US Army Corps of Engineers

Donlin Gold Project EIS

Comment Form

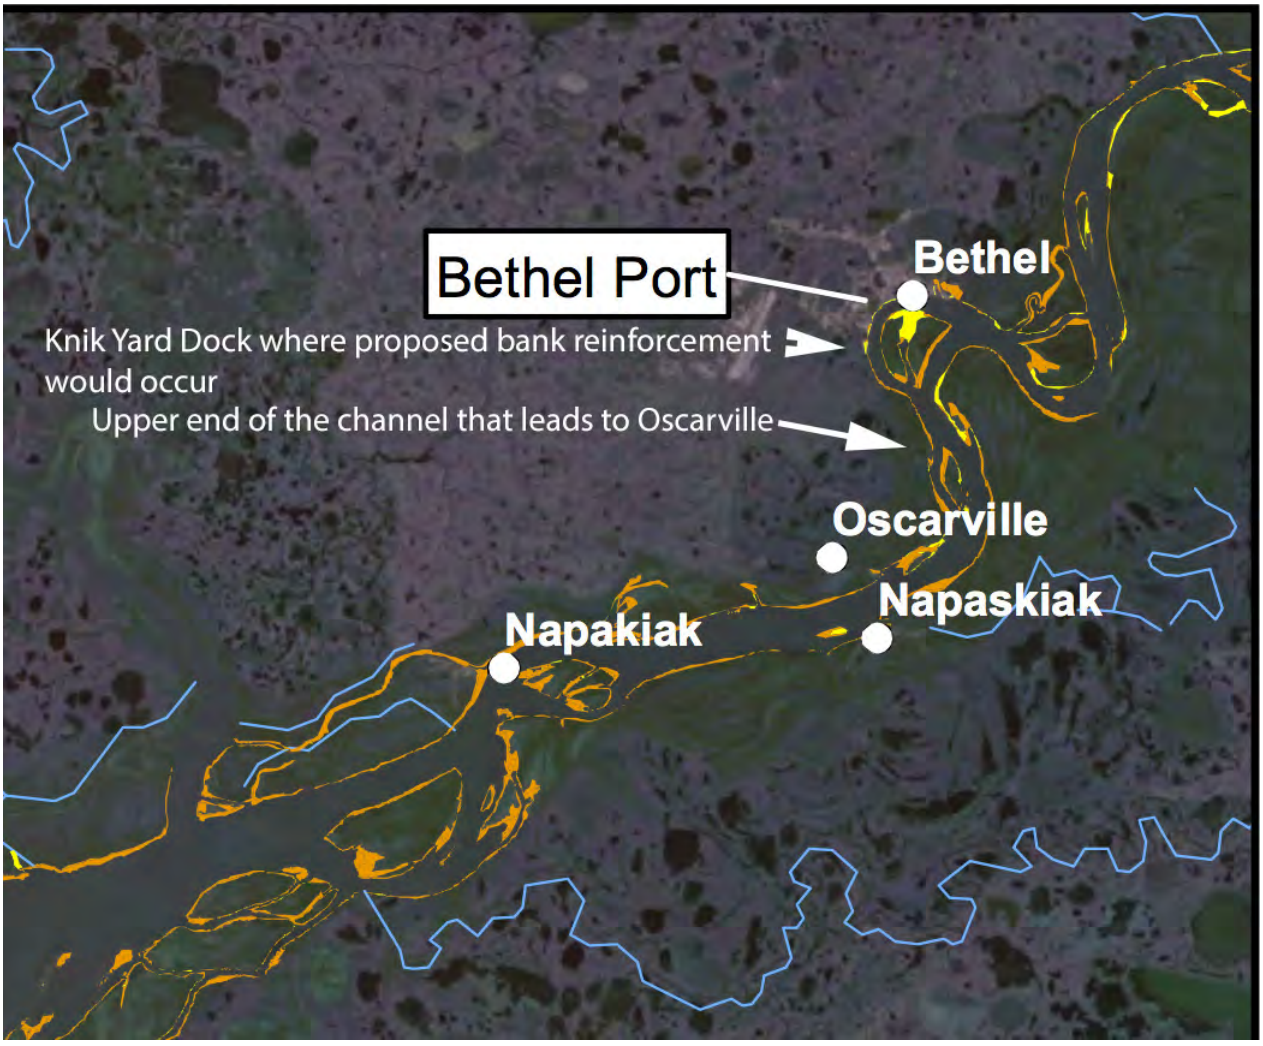
The figure below is taken from Figure 3.5-13 of the DEIS and denotes the depositional areas in yellow and the actively eroding sections of channel in orange. Note how the upper end of the side channel that flows past Oscarville (and is less than one mile below the proposed port site) is labeled as susceptible to erosion as well as much of the west bank of the Kuskokwim River between Bethel and Oscarville.

BARG 11

114-570031
CROOKED CREEK, ALASKA
09/2013
Figure 2-1

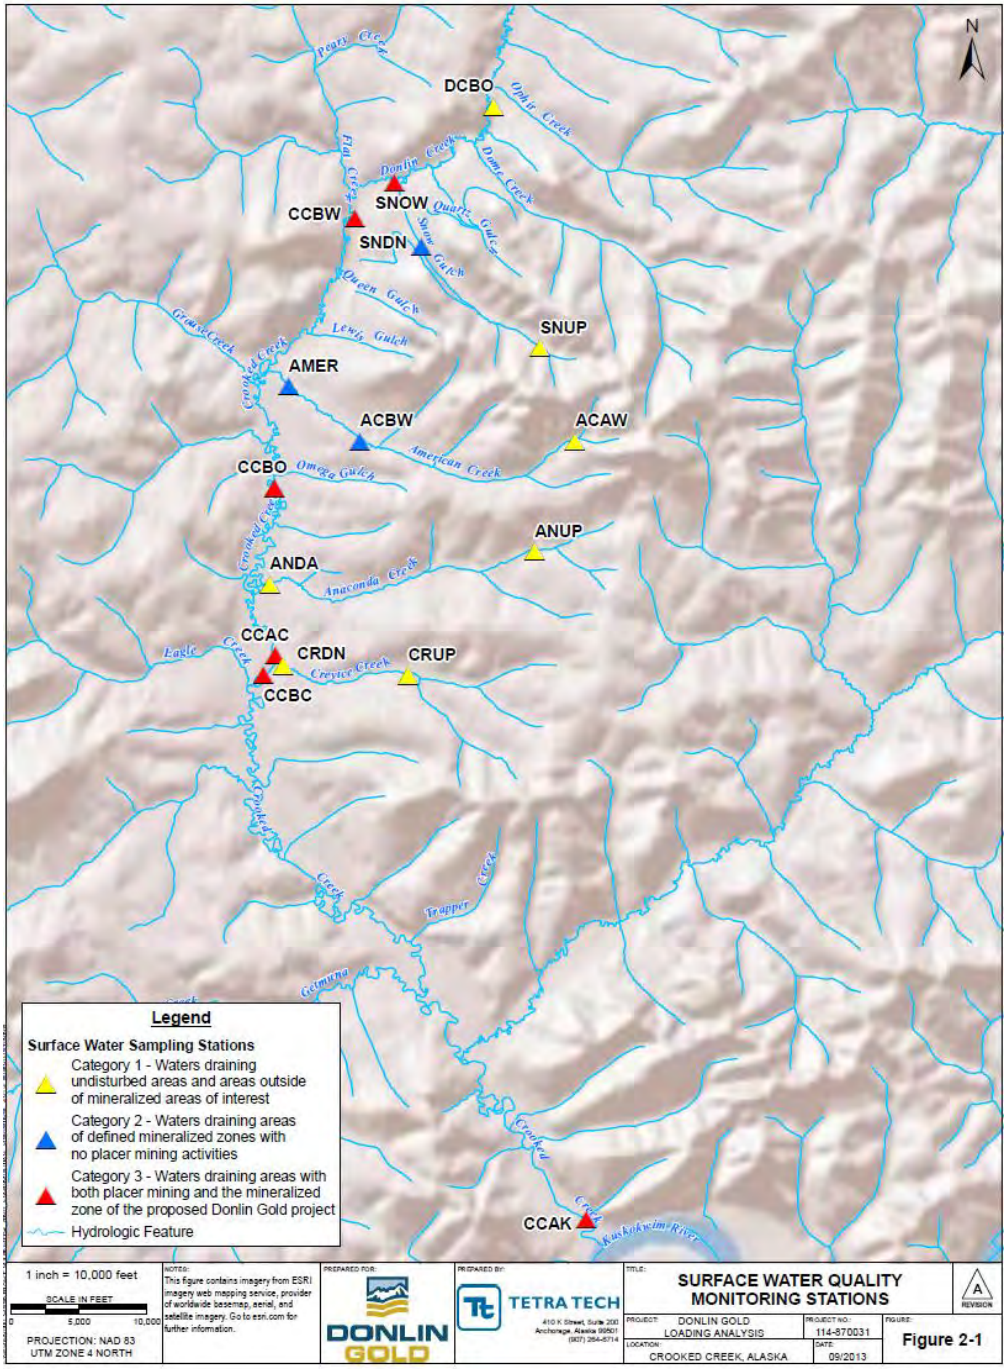
- **Recommendation: Sampling should not exclude sites that could promote methylation.** Sample sites for analysis for sulfate in soils, and other indicators relevant to methylation rates should be based on a geographical grid of environments that mercury may enter, through dust or atmospheric deposition.
